भारत सरकार - रेल मंत्रालय
अनुसंधान अभिकल्प और मानक संगठन
लखनऊ - 226011
Government of India-Ministry of Railways
Research Designs & Standards Organisation
Lucknow - 226011

MODIFICATION SHEET No. ELRS/MS/0271-2004, REV. '1'

Standardisation of High Capacity Vertical DBR Units with 30 KW AC MVRF in Freight Electric Locomotives.

REF.	PART NO.	DESCRIPTION	DETAIL DRG. NO.	MATL.	SPEC. NO.
REF.		SCALE	APPD. BY	(For DG)	
AUX. CONTROL CKT. OF AC MVRF(30 KW) FOR ARNO / STATIC INVERTOR LOCO				FIRST ISSUED, OCT. 2004	
RDSO ELECT. DTE.				SUPERSEDES	
SKEL-4685 ALT. '0'				SUPERSEDED BY:

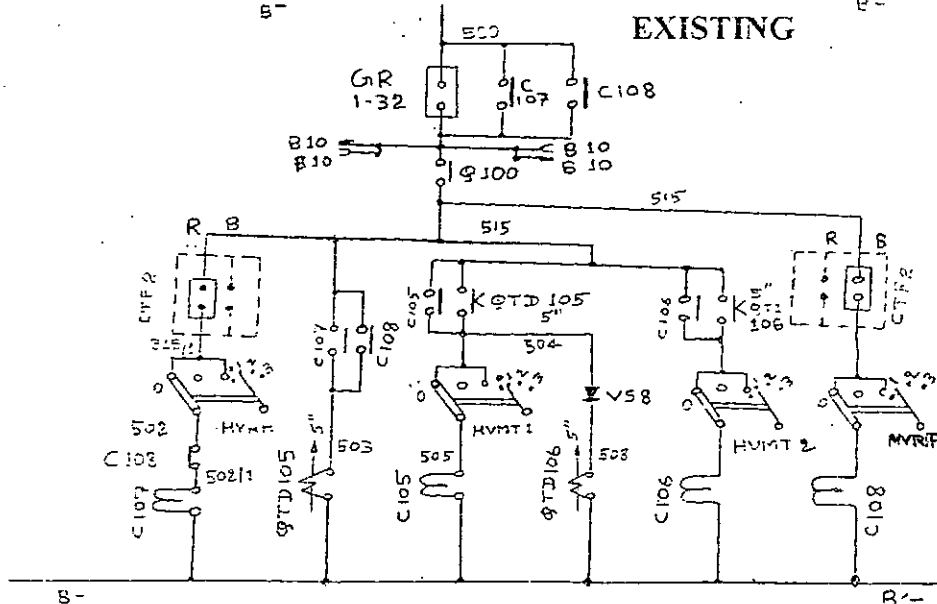
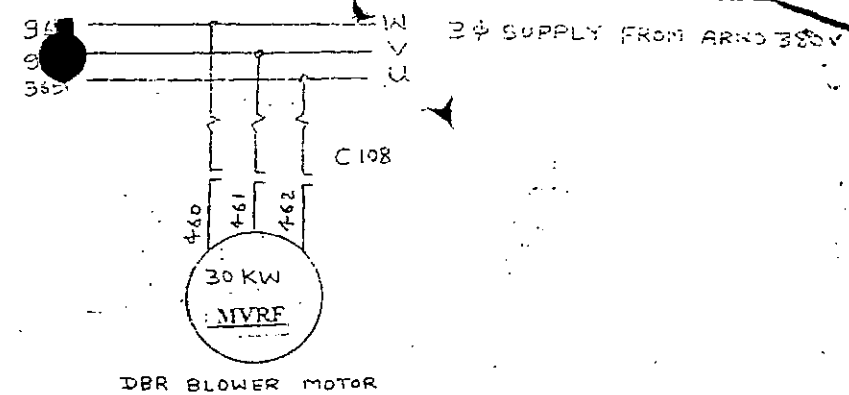
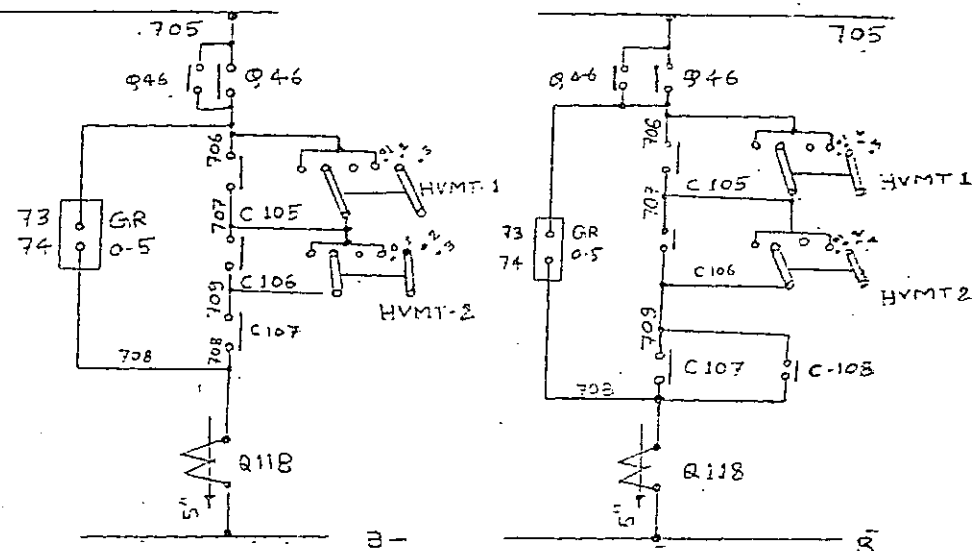
The modified circuit diagram SKEL- 4685 for operation of AC MVRF by switching 'OFF' MVRH. This modified circuit diagram is common for locomotives equipped with static inverter as well as Arno Converter.

EXISTING

MODIFIED
